## Rearview Camera Noise Optimization

Topic number	LI54.71-P-080180
Version	2
Function group	54.71 - Camera and radar-assisted assistance systems
Date	2/19/26
Validity	167 Facelift (GLE) with the following:  - Model Year 2024 and later (Option code 804, 805, etc...)  - Option Code 491 (Steel Spring Variant)  - Option Code 235 (PARKTRONIC with Active Parking Assist)
Reason for change	Op No/DC added

View PRIOR to SCN Coding:

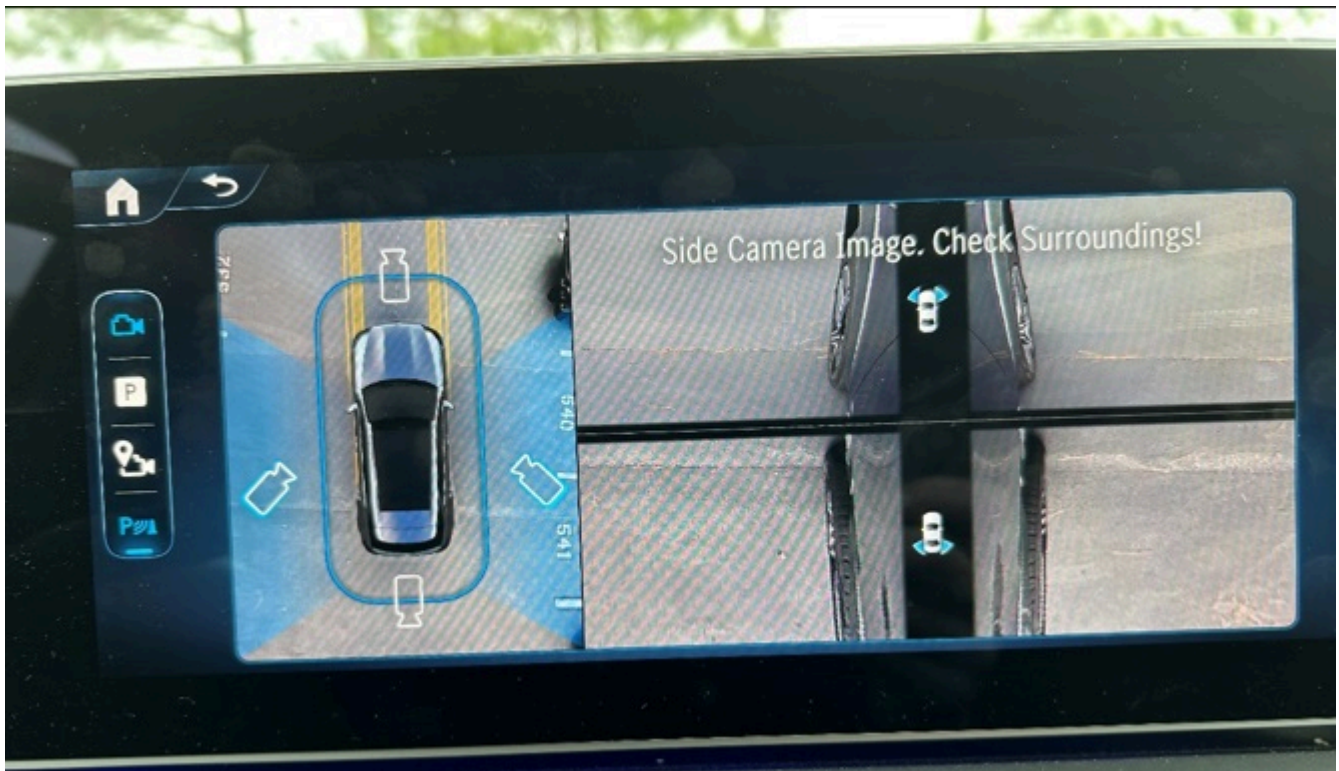
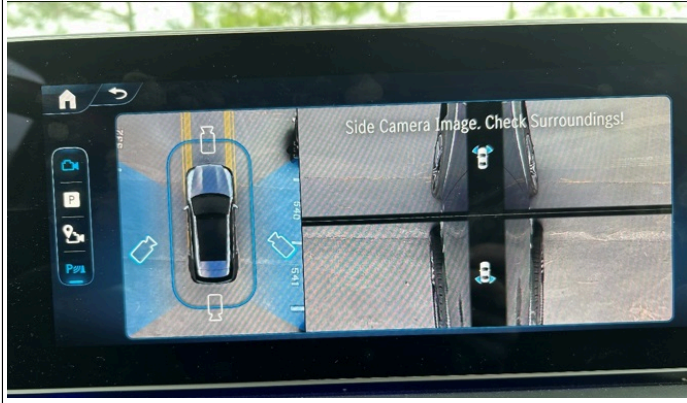
**IMPORTANT:** After both control units have been SCN coded, the "Movable 3D View" feature in the head unit will no longer be available. With this change there will be two distinct differences:

- 1) The "3D" icon when in the top down vehicle view, will no longer be present on the head unit.
- 2) The digital rendering of the vehicle with the ability to spatially move around the vehicle is no longer possible. This view is replaced with 2D static images of the left and right sides.

- Rear camera flap when calibrating after a key cycle bus sleep will stay open to 29 MPH and then close. Will re-open, when calibrating, at 9 MPH.
- The head unit screens mentioned above appear the same as "View AFTER SCN Coding" as shown in the attachment.
